XC2700 Derivatives

16/32-Bit Single-Chip Microcontroller
with 32-Bit Performance

Errata Sheet

V1.7 2014-10

Figure 1 Critical application reset sequence

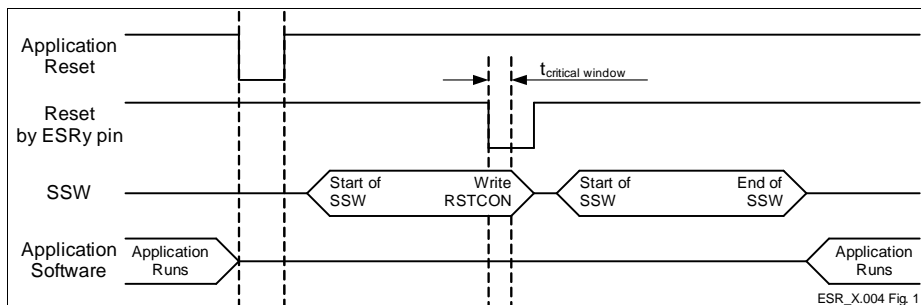
ESR X.004 Wrong Value of SCU_RSTCONx Registers after ESRy Application Reset

SCU_RSTCONx registers are reset only by Power-On, but they may be wrongly affected after a second application reset requested by an ESRy pin. This may lead to the SCU_RSTCONx register values being set to zero, which could unexpectedly disable reset sources within the user application. The conditions which lead to this behavior are:

1. First, an application reset by SW (software), CPU (Central Processing Unit), MP (Memory), WDT (Watchdog Timer) or ESRy (External Service Request y) occurs.
2. Following this, an application reset on an ESRy pin occurs.
3. If the above mentioned ESRy reset occurs during a critical time window of the SSW (startup software), then it's possible that the application will operate with the wrong SCU_RSTCONx register value. The critical time window occurs when the SSW is writing the SCU_RSTCONx registers, and at the same time, the ESRy reset request is processed by the reset circuitry. The width of this critical window $f_{critical\ window}$ is less than 13 cycles.

- Initialize `SCU_RSTCONx` registers by user software after any reset, or
- assure that a second application reset request with an ESR pin does not occur during the critical time window.

Figure 2 Example for Case 2: Interrupt Service for Task C delayed

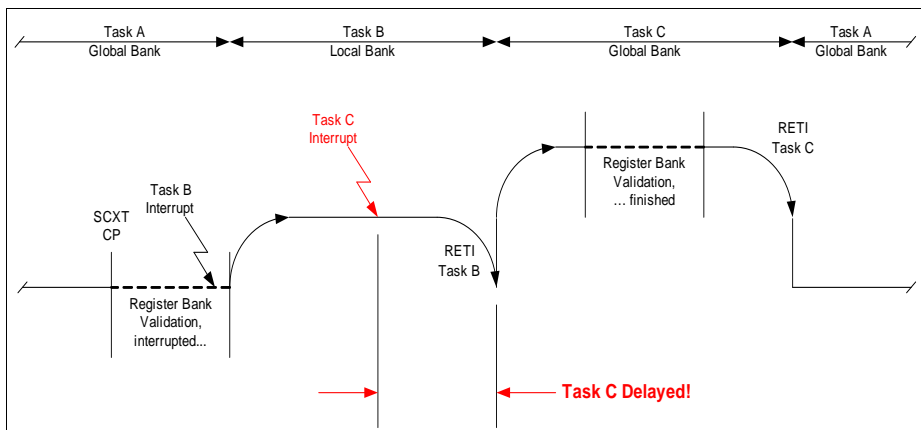
Case 2 (see also Figure 1):

- The Context Pointer CP is written to (e.g. by POP, MOV, SCXT ... instructions) within a routine (Task A) that uses a **global** register bank (bit field PSW.BANK = 00_B), i.e. the context for this routine will be modified,
- This context switch procedure (19 cycles) is interrupted by an interrupt request (Task B) which is programmed (with GPRSELx = 1X_B) to automatically use one of the **local** banks via the bank selection registers BNKSEL0...3 (i.e. the interrupting routine has a priority level ≥ 12),
- Before the corresponding interrupt service routine is finished, another interrupt request (Task C) occurs which is programmed (with GPRSELx = 00_B) to automatically use the **global** bank via the bank selection registers BNKSEL0...3 (i.e. the interrupting routine has a priority level ≥ 13).

In this case service of this interrupt request (for Task C) is delayed until bit field PSW.BANK becomes 00_B after executing the RETI instruction at the end of the routine (Task B) using the local bank.

Workaround for Case 2

When using both local and global register banks via the bank selection registers BNKSEL0...3 for interrupts on levels ≥ 12 , ensure that there is no interrupt using a global register bank that has a higher priority than an interrupt using a local register bank.

Figure 7 External Clock Drive XTAL1

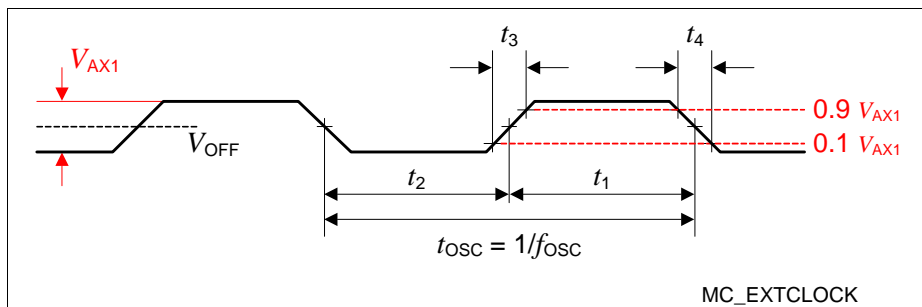
In the Data Sheet section "External Clock Input Parameters" the following table and figure should be updated (major changes are marked **red**).

1) The amplitude voltage V_{AX1} refers to the offset voltage V_{OFF} . This offset voltage must be stable during the operation and the resulting voltage peaks must remain within the limits defined by V_{IX1} .

Note: For crystal or ceramic resonator operation, it is strongly recommended to measure the oscillation allowance (negative resistance) in the final target system (layout) to determine the optimum parameters for oscillator operation.
The manufacturers of crystals and ceramic resonators offer an oscillator evaluation service. This evaluation checks the crystal/resonator specification limits to ensure a reliable oscillator operation.
